**Re: DA2019/1280 – 60-62 Beaconsfield Street and 7-13 Queens Parade,
Newport**

During this time the project team has been monitoring submissions received by Council and published on the Council's web site and internal referral responses. This letter summarises the issues that have been raised through this process, how the design responds to those issues, and provides additional information to assist Council in its assessment of the proposal.

Note that to respond appropriately to the issues that have been raised minor amendments have been made to the proposal. These amendments are submitted to Council pursuant to clause 55 of the *Environmental Planning and Assessment Regulation 2000*.

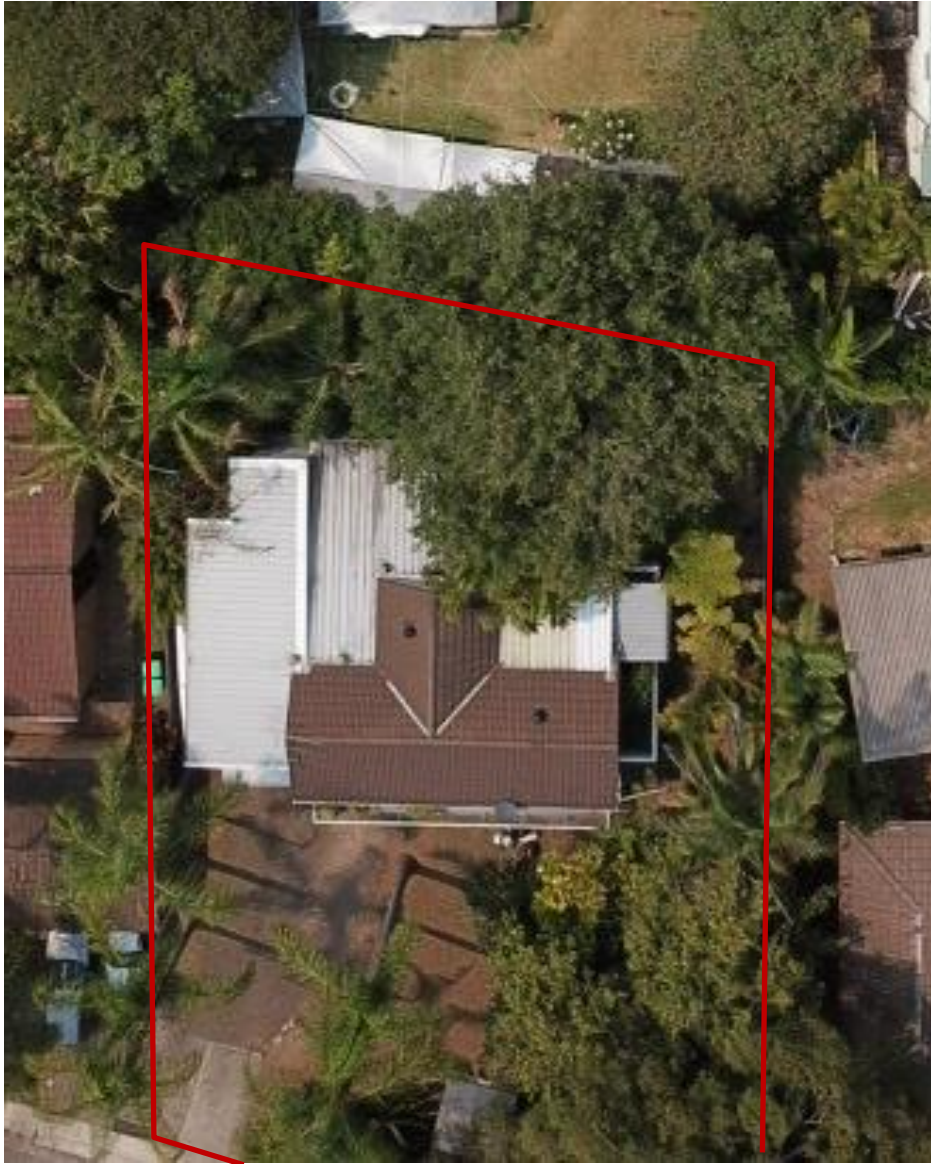
To address this concern the proposal has been amended in consultation with Council's Urban Design Officer to lower the structures near the boundary to 58 Beaconsfield Street.

The proposal provides for car parking to be located adjacent to the rear boundary of 58 Beaconsfield Street. The car parking is set below the level of the subject site at RL20.3 such that it is at approximately the same level as the rear yard of 58 Beaconsfield Street (note the spot level of RL20.28 adjacent to the rear boundary of 58 Beaconsfield Street).

The proposal as submitted to Council proposed that a garden terrace extend over the car parking at a level or RL24.6, ie: 4.3m above the level of the rear yard of 58 Beaconsfield Street. The proposal as amended steps the landscaped area down as it nears the boundary with 58 Beaconsfield Street. Immediately adjacent to the boundary the proposal is at ground level, then there is a planter box with falling plants creating a green wall up to RL23.7, as shown in the following drawing:

Photograph 1: 58 Beaconsfield Street – 3pm, 14.1.2020

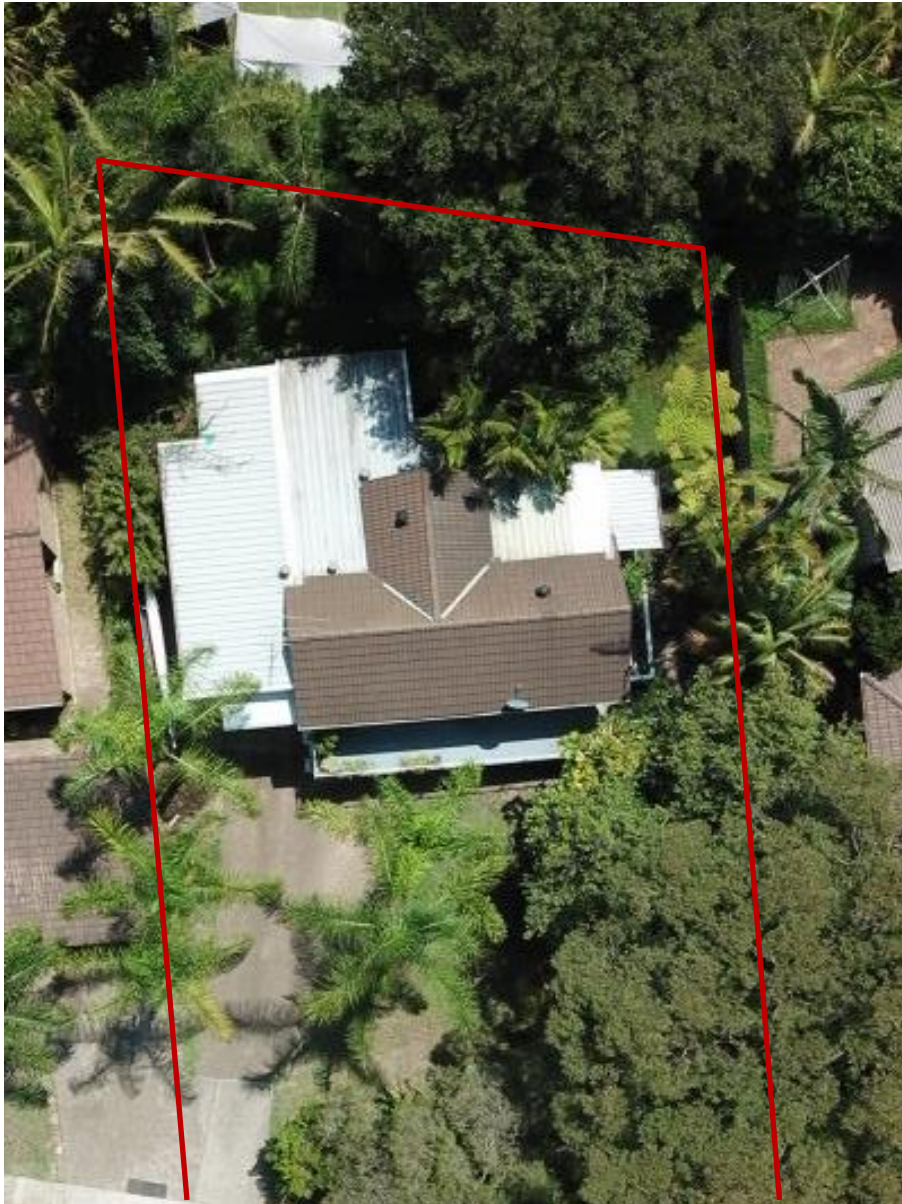
Fourthly, the rear yard of 60 Beaconsfield Street is overshadowed by existing vegetation whilst the front yard retains generous solar access. This circumstance

is clearly contemplated in the DCP controls which refer to “*existing vegetation... that overshadow*”. The overshadowing from existing vegetation and the retention of solar access to the front yard of 58 Beaconsfield Street, is shown in the following aerial photographs:
